**Charlotte-Mecklenburg Planning, Design, & Development**

**SUBJECT:** Administrative Approval for Petition No. 1996-009C Shopping Center Group, Inc

# CITY OF CHARLOTTE, MECKLENBURG COUNTY, NORTH CAROLINA CONSTRUCTION DOCUMENTS FOR **STARBUCKS AT DAVIS LAKE**

SHEET NO.  
C4.0

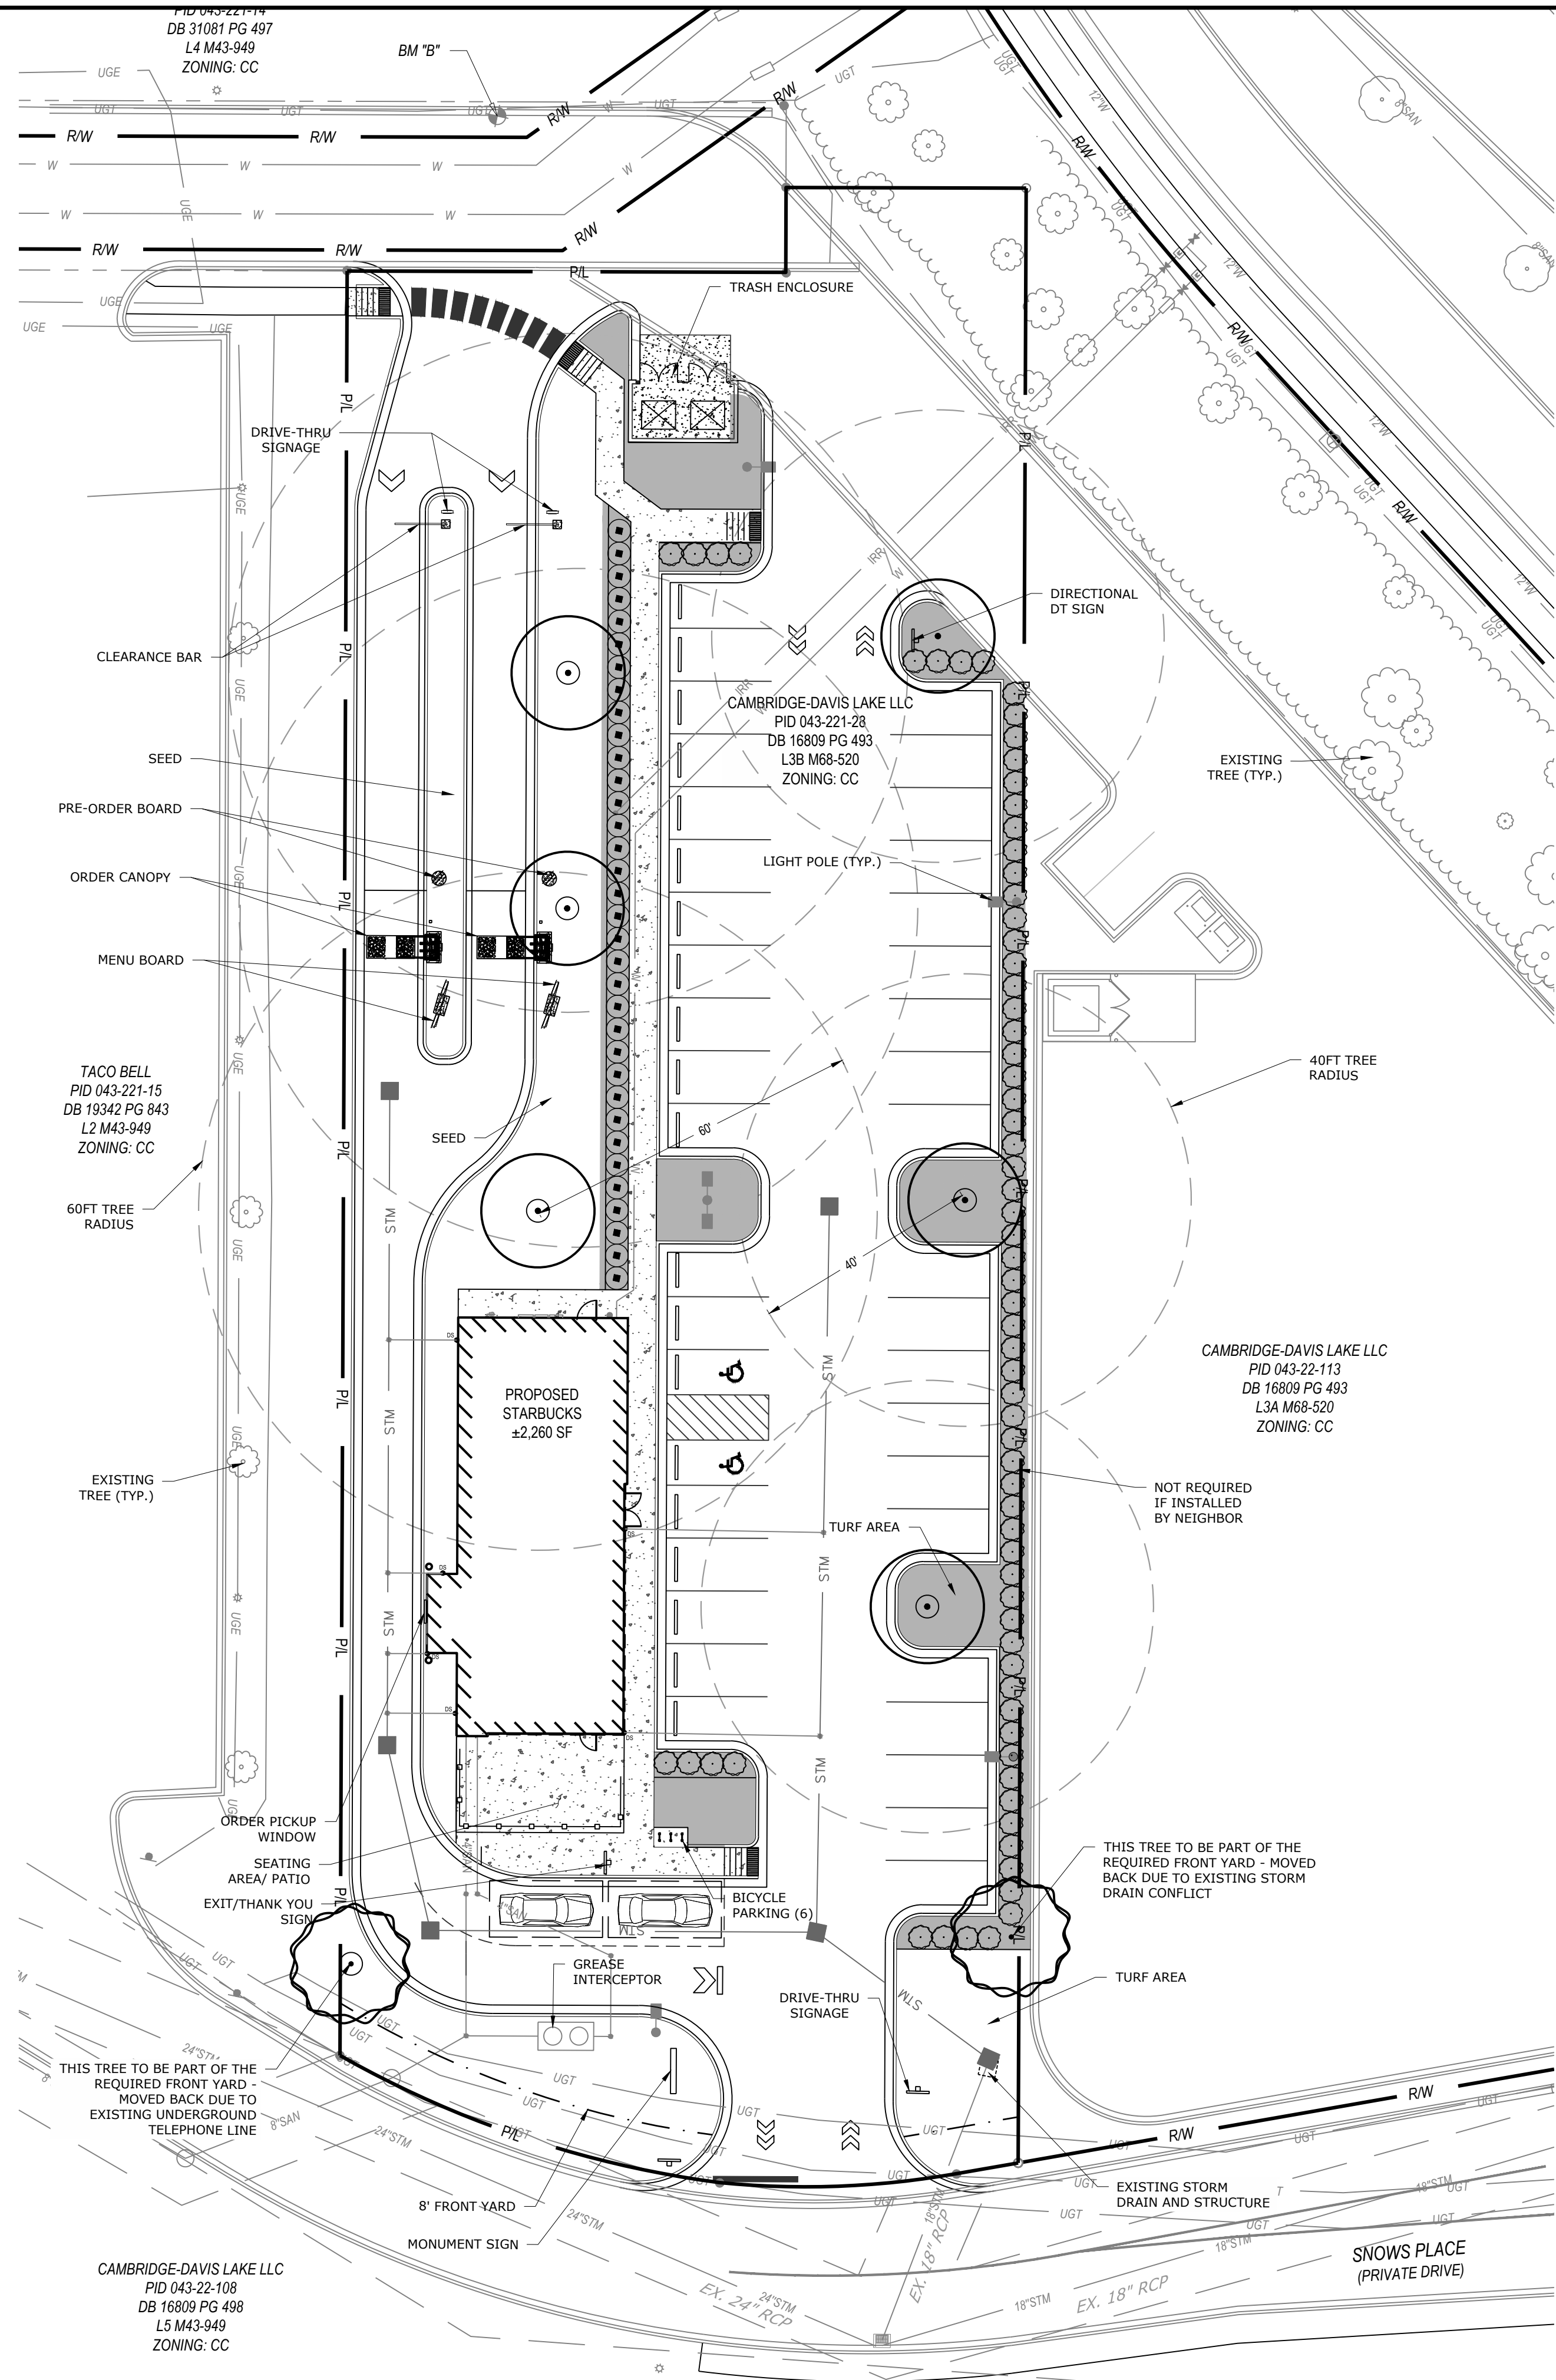
- To allow a new EDEE (Starbucks).
- Landscaping plan
- Building elevations.
